Re: Canvasback Subdivision

I have reviewed the application to have RP05N45E010500 subdivided into three (3) lots to be known as the Canvasback Subdivision and determined that the property is suitable for sub-surface waste disposal systems to serve residences. Test holes excavated on August 4, 2022, to allow observation of the soil horizon to ten feet below natural grade. Following is description of the soils on the property. All test pits presented basically the same soil layering with minor differences in thickness of the layers

SUBDIVISION ON-SITE

TEST HOLE INFORMATION

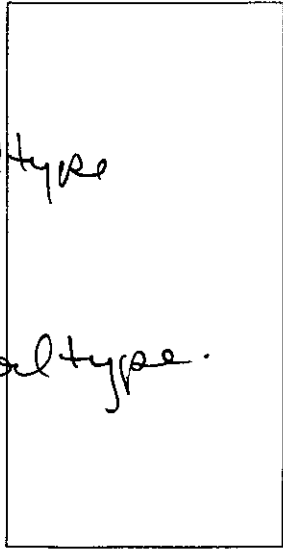
All test holes show same soil horizons.

12" — Topsoil silt loam
Clay silt with some sand
Mica rock toward bottom - of layer.
Loess
66" — coarse sand + gravel
Alluvium A2A soil type.
COBBLES + 6" diameter
45-50% rock content.
some larger cobbles (10")
Dry / No bedrock.

5 Test Holes.
